LIGO- T0900629-v2

ADVANCED LIGO

Response to questions from the review panel on the
Final Design Review of the ETM/ITM ears

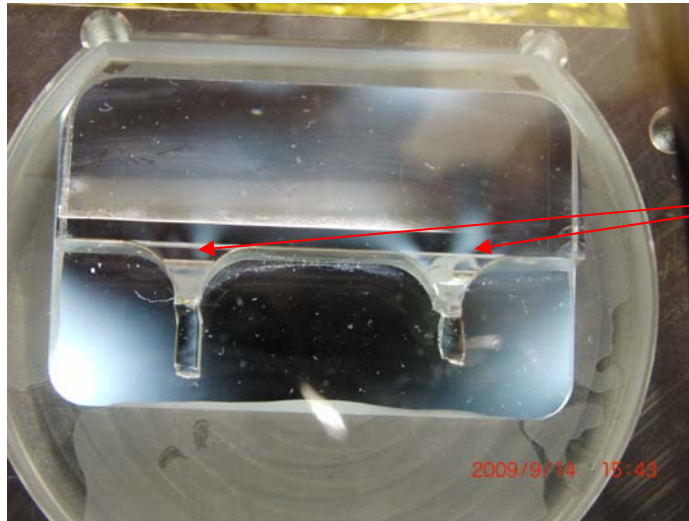
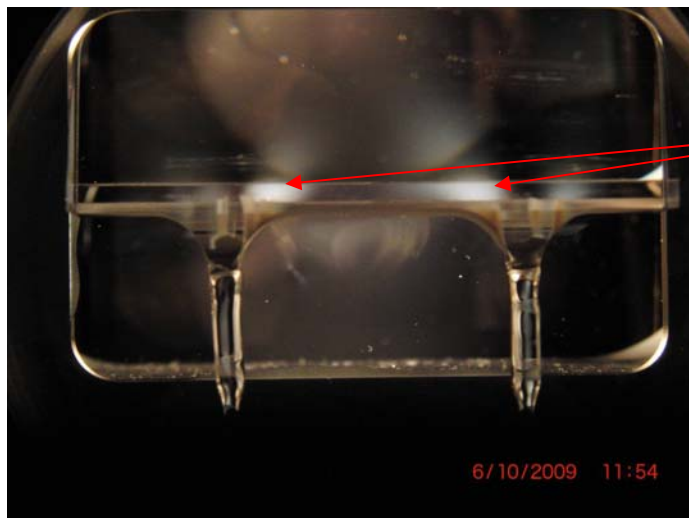
Q Is there, or has there ever been, a check on residual stress in the ears after bonding?

A Yes, residual stress after bonding and stresses in the ears after welding have been checked using crossed polarisers. No stresses have been observed in unloaded bonded ears.

Some stresses have been observed after welding, with no load. And some additional stresses have been observed when the fibres are under load. In those cases a white hue-type glow is seen. It is difficult to quantify the stresses, however the stresses seen have low intensity glows. Much higher intensity glows have been observed in samples that have been exposed to thermal loading (heating with hydrogen oxygen flame).

No stresses in bonded ear that has not been welded

Typical thermal stress ranges after welding and welds not loaded

Stress in ear after laser welding, no load

Typically stresses become slightly more pronounced when under tension

Stress in ear under full tension
